#### **Airworthiness Criteria: Airship Design Criteria for Zeppelin Luftschifftechnik GmbH Model LZ N07 Airship**

**ACTION:** Notice of issuance of final design criteria.

**Figure 3: Dihedral Angles for Position Lights**

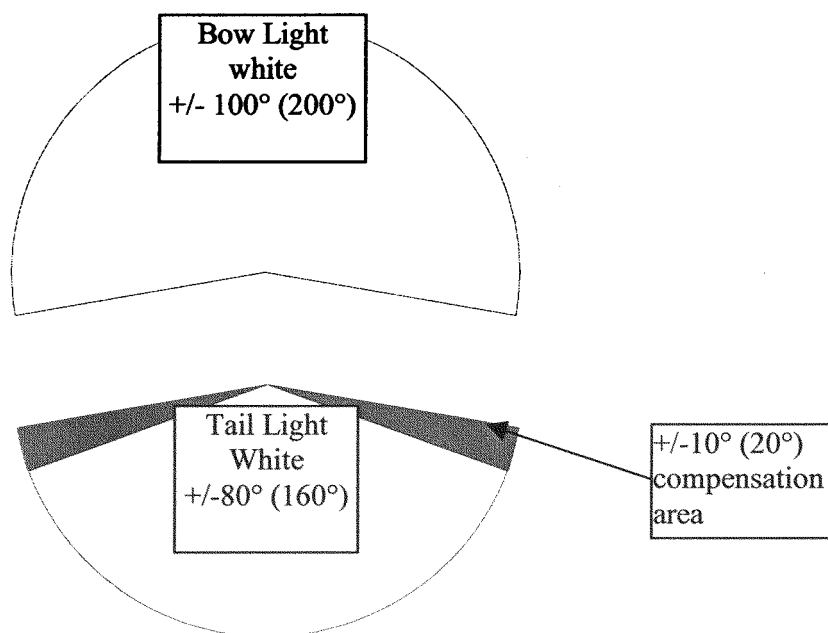
LFLS Section 2498(b) and ADC paragraph 6.25 specify the position lighting requirements for airships. It is not understood why a dispensation should be given for something that can be easily fixed with properly TSO’d LED or similar lighting. ABC had to go through a stringent certification of the lighting on the one model. This was revisited in a new model and the FAA

asked ABC to modify our position lighting by providing two sets of bow lights in slightly different positions to further ensure adequate brilliance in all sectors. It is not understood why any latitude is being given to this basic legal requirement affecting safe navigation of aircraft.

The FAA notes that there is no LFLS section 2498(b) and that the comparable LFLS section to ADC section 6.25 is LFLS section 1385. The only section where an equivalent level of safety to the LFLS lighting requirements was granted by the LBA is LFLS section 1387(b). The LBA granted this equivalency based on what was considered compensating features of the lighting system installed on the LZ N07-100, and the FAA agreed.

LFLS § 1387(b) requires a dihedral angle formed by two intersecting vertical planes making angles of 110 degrees to the right and to the left. LFLS appendix table 10 requires, in addition, a minimum light intensity of 20 cd throughout the dihedral angle. The LZ-N07 system only attains the required intensity over 100 degrees but is still visible from 100 degrees to 110 degrees (left and right) at a reduced intensity. The LBA granted an equivalency to LFLS § 1387(b) based on the greater dihedral angle coverage of the aft light, +/-80 degrees rather than +/-70 degrees at the specified intensity. This is acceptable to the FAA.

The LFLS § 1387(b) required dihedral angle will be no less than 100 degrees at the intensities specified in Table 10 of the appendix of the LFLS. In addition, the rear light will have an included angle of +/-80 degrees at the specified intensity from Table 10 of the appendix of the LFLS. Refer to Figure 3.
